Rampion 2 Wind Farm

Applicant's Comments on Deadline 4 Submissions

Date: July 2024
Revision A

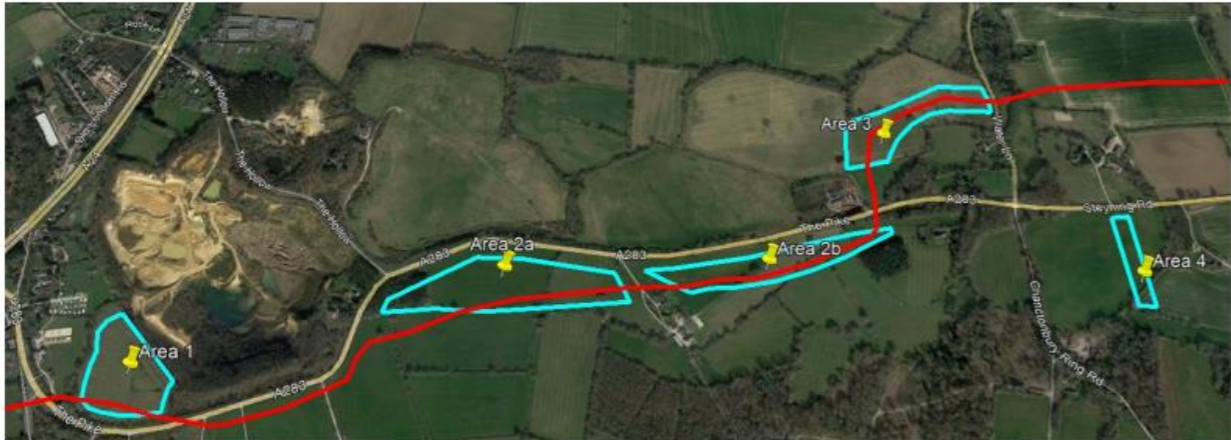
2.30.15 We note the Applicant's Order Limits are much wider than the construction corridor they will need as they required a degree of flexibility before they carry out detailed design. We have calculated the impacts of sterilisation on minerals using a worst case scenario as a result of this flexibility. However, we have also applied a level of conservatism to our estimate based on information provided by the previous and current operators of Rock Common Quarry, as is set out below.

The information used for the high level assessment identified in 2.4.1, is provided within Rampion 2 Cable Route Alternatives & Mineral Sterilisation [REP4-136] and is based on historical information for which the authors themselves note they do not have available the detail which underpinned those historic calculations. In the following sections, the Applicant has noted where this data appears unreliable or could be interpreted to provide differing results to those provided. It is also noted that the Wiston Estate have used similar assumptions in Rampion 2 Cable Route Alternatives & Mineral Sterilisation [REP4-136] to those used by the Applicant (e.g. the buffer zone from the highway). It is the Applicant's opinion that these inconsistencies and the use of assumptions reinforce the Applicant's position that the exact

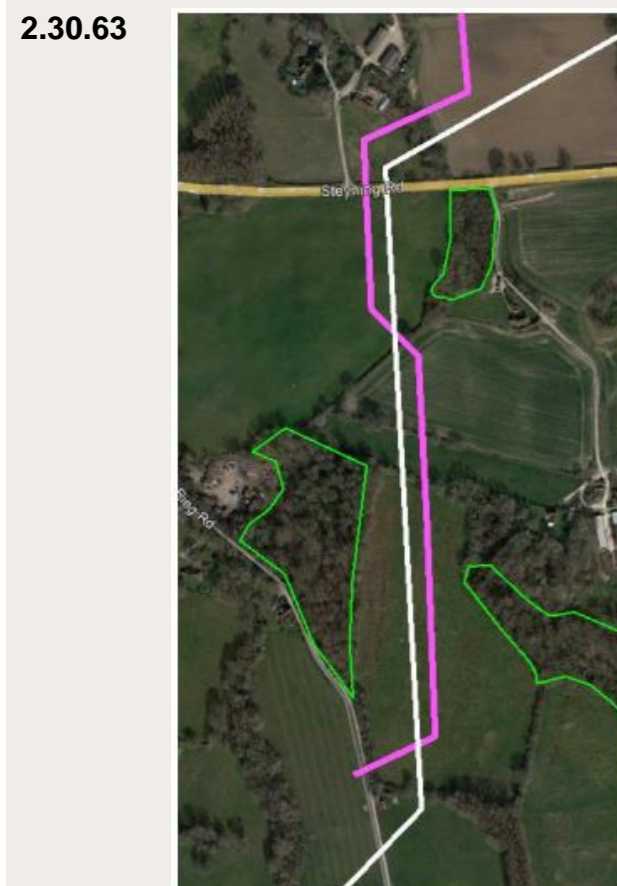
also aware of the protective provisions in relation to the pipeline apply from the point at which works are taking place within 15m of the gas assets. Applying the advised buffer to the Ancient Woodland and the gas pipeline leaves a corridor of 30m within which to install the cables. Whilst this is narrower than the 40m construction corridor, based on our knowledge and experience, it will still be possible to install the cables in this area by making minor modifications to the installation process. This route is shown by the pink line below. The approximate location of the gas pipeline is shown in white and the approximate outline of the ancient woodland is shown in green in the aerial view titled 'Sawyers Copse – Option 1' below.

Additionally, the actual position of the gas pipeline would need to be confirmed via surveys, as it is often the case that the recorded position for services is not accurate. Given these spatial constraints and prevailing uncertainty around the ability to determine a construction design that would be acceptable to the gas pipeline operator, the Applicant has concluded this would present a high risk to deliverability of the scheme.

Sawyers Copse - Option 2

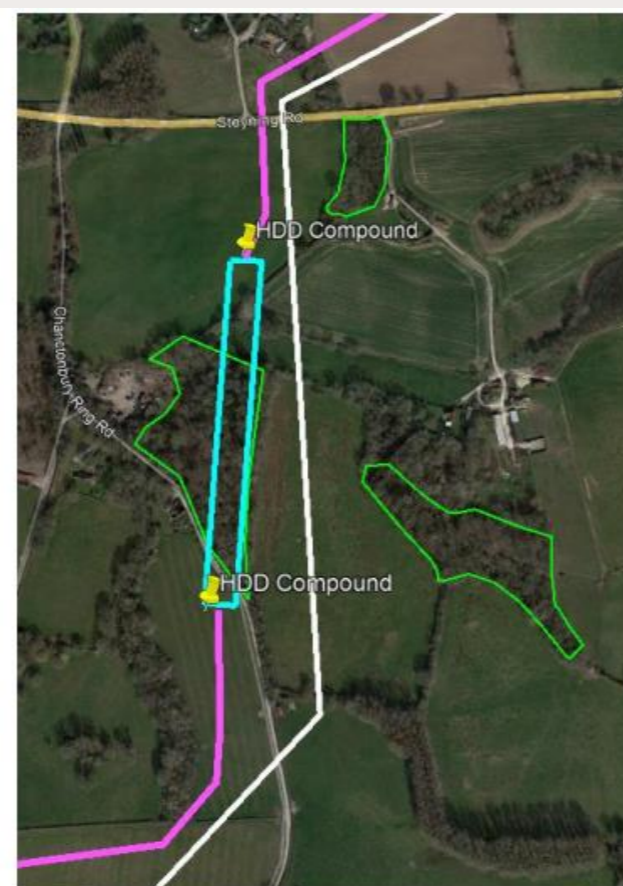
The works for this alternative would also be within 50m of the Chanctonbury Hill Site of Special Scientific Interest (SSSI), although this is likely to be managed effectively through appropriate mitigation (dust suppression etc.). As well as passing closer to the SSSI the alternative crosses more hedgerows and tree lines than the selected route.

The above figure shows the difference between the Applicant's 250m separation distance and Aquind's 1000 metre separation distance

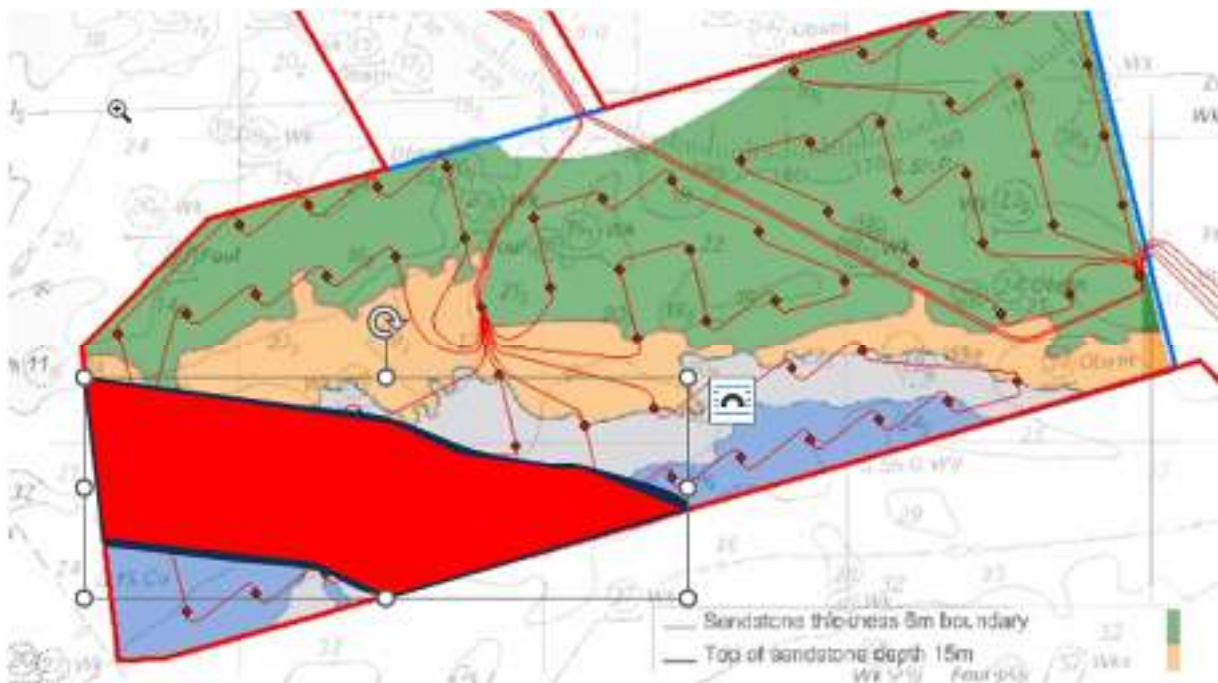
The above figure shows the extent of seabed within the Rampion 2 DCO Order limits that would be subject to Aquind's proposed 1000 metre separation distance within which no turbines could be erected without Aquind's consent.

- 7.1 The Applicant's position is that a required separation distance of 1000m is not justified on safety or operational grounds for the reasons set out in this note. Furthermore, such a separation distance would effectively sterilise that area of Rampion 2 Order limits and prejudice the Applicant's ability to deliver the Rampion 2 Scheme effectively and efficiently and in line with the government's objectives for new offshore wind capacity by 2030.
